Our reference: MGLA240222-5297

From: [REDACTED] >
Sent: 04 February 2022 23:54
To: Popes Road; Mayor of London; [REDACTED] John Finlayson
Subject: 20-24 POPES ROAD (GLA Stage 3 ref: 2021/0265) - 2nd REVISION - Environment (objecting)
Attachments: Pope Road - Written Representation - 3.pdf

20-24 POPES ROAD (GLA Stage 3 ref: 2021/0265) – 2nd Revised Plan

20-24 POPES ROAD (GLA Stage 3 ref: 2021/0265)

The applicants Fire Assessment dated 17th December 2021 includes a fire service site plan as shown below.

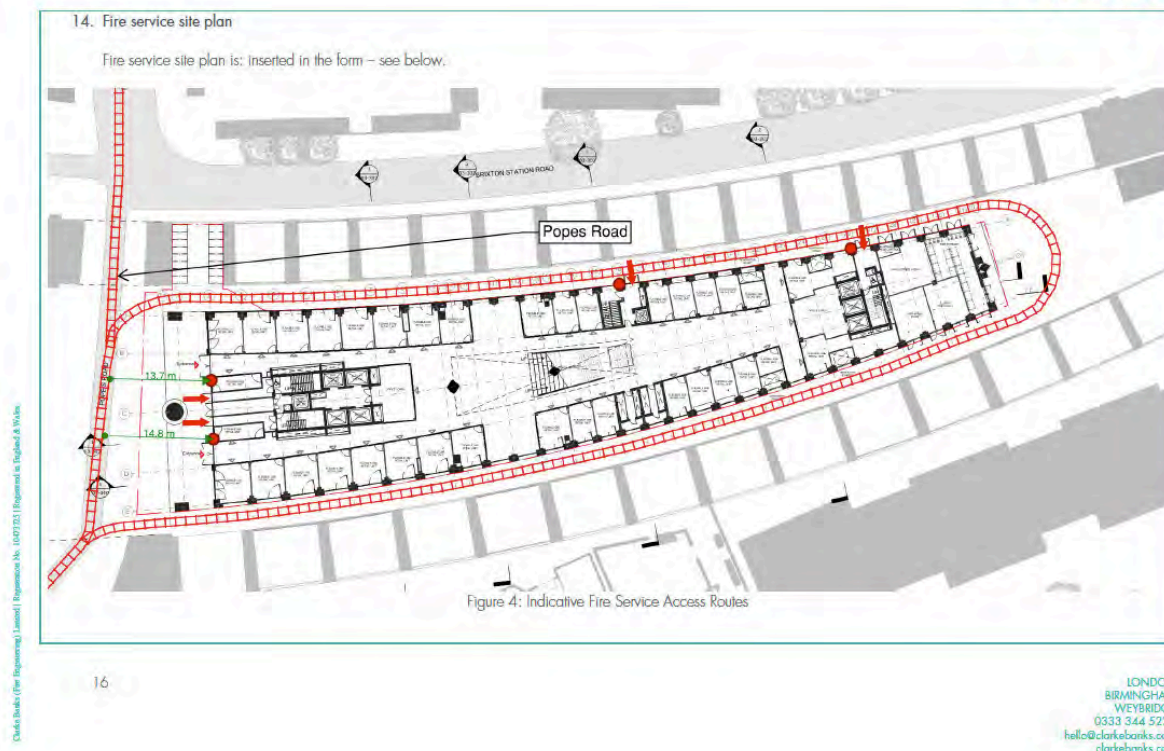
The applicants' fire assessment confirms at item 11 on page 14 that emergency road vehicles can access the side entrances indicated on the site plan, but that the access routes on the north and south facades would be subject to a tracking assessment and later detailed drawings in order to confirm that they meet the requirements of the LFB Guidance Note 29 with respect to access for pumping appliances.

Using the scale rule provided on the applicants site plan drawing, it is also clear that although a pumping appliance might just about be able to park within 18m of the entrance to the east of the building, such access to the central entrance would not be possible. In addition, due to the narrow width between the building and the railway viaduct to the north, **neither entrances would be readily visible from a point at which a pumping appliance could be stationed.**

As indicated on the applicant's east elevation drawing, the 9 storey element of the proposed development is over 36.25m high

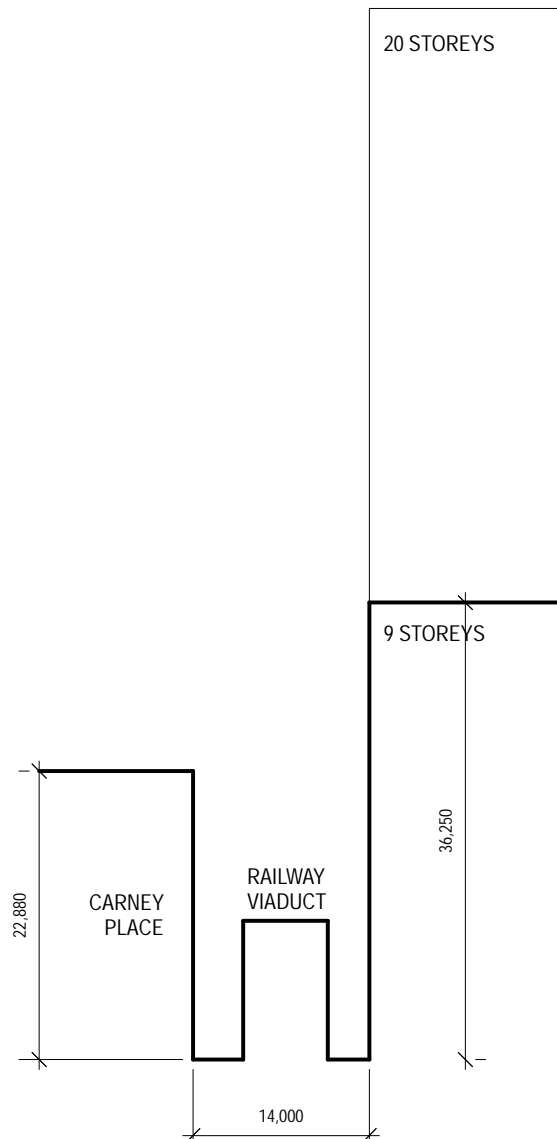
This shows that the 9 storey element of the proposed development would be substantially taller than the building(s) at 368-372 Coldharbour Lane and that the 20 storey element would completely dwarf neighbouring buildings.

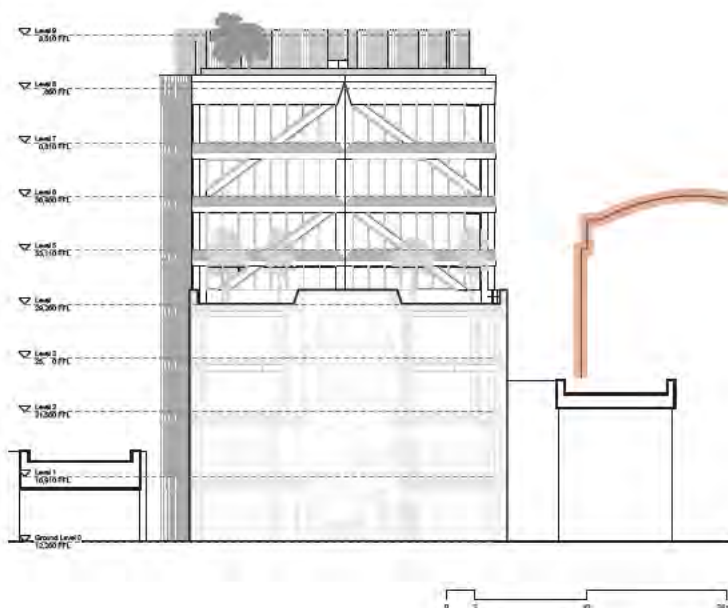
We would draw your attention to the proposed drawing below provided by the applicant which demonstrates the heights of their proposals against our, significantly lower development:

Figure 1. Hondo Tower: Energy Saved vs. Embodied Carbon Emissions

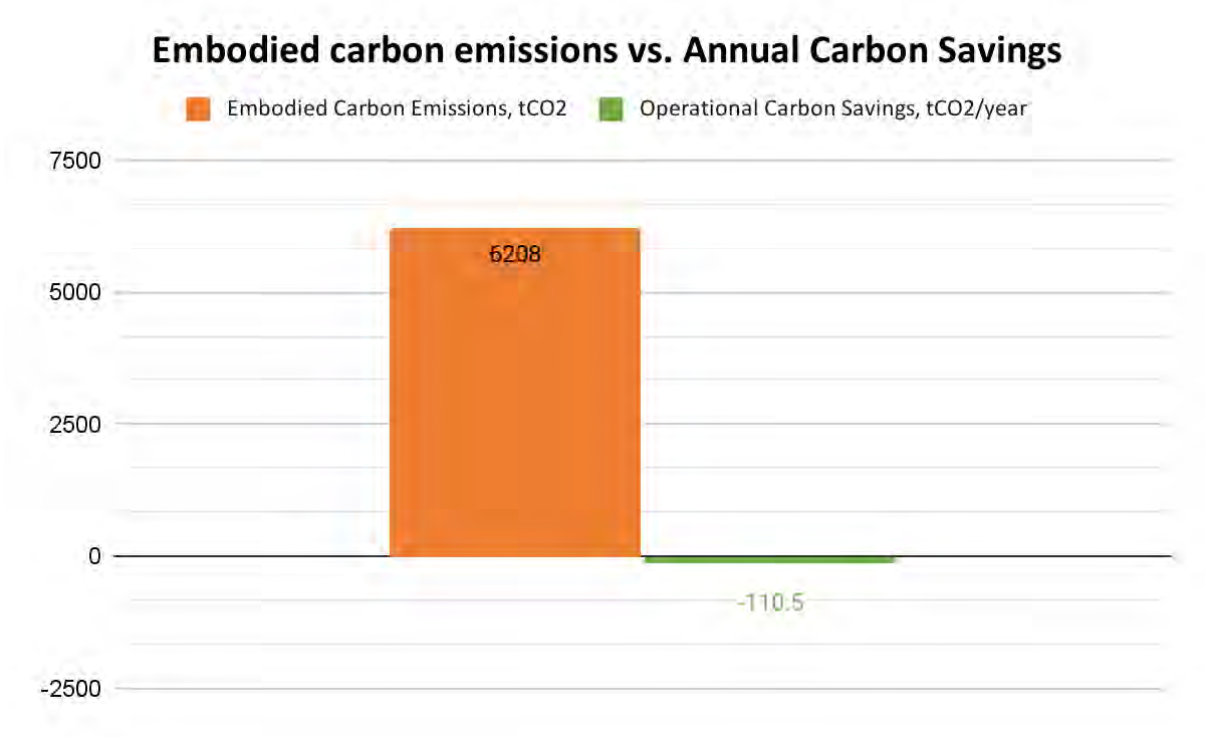
When a 60 year life span for the building is assumed, the embodied carbon footprint is effectively offset from year 56. However, when operational and embodied carbon are taken into account together, it becomes apparent that the energy savings pale in comparison to the total carbon emitted by the development (Figure 2).

The applicants Fire Assessment dated 17th December 2021 includes a fire service site plan as shown below.

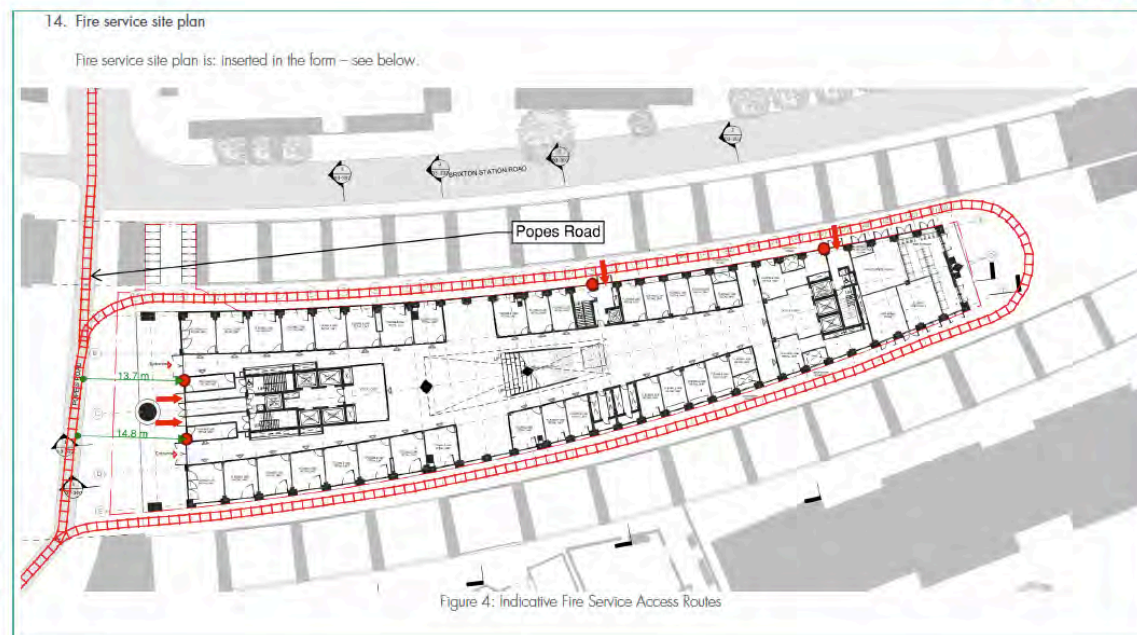
- Fire Service vehicle access will be provided via Pope's Road as well as the new private roads the north and south of the building on site. This arrangement is shown indicatively in Figure 4 of this report;
- This will allow fire appliances to park within 18m from, and have a clear line of sight to, the wet rising main inlet points for all cores. Immediate access into the firefighting lobbies or stairs will be provided next to the wet rising main inlet points (shown as red arrows in Figure 4 of this report);
- The vehicle access route suitability for Fire Service appliances (on the aforementioned public roads) should be confirmed via tracking exercises at a later date.
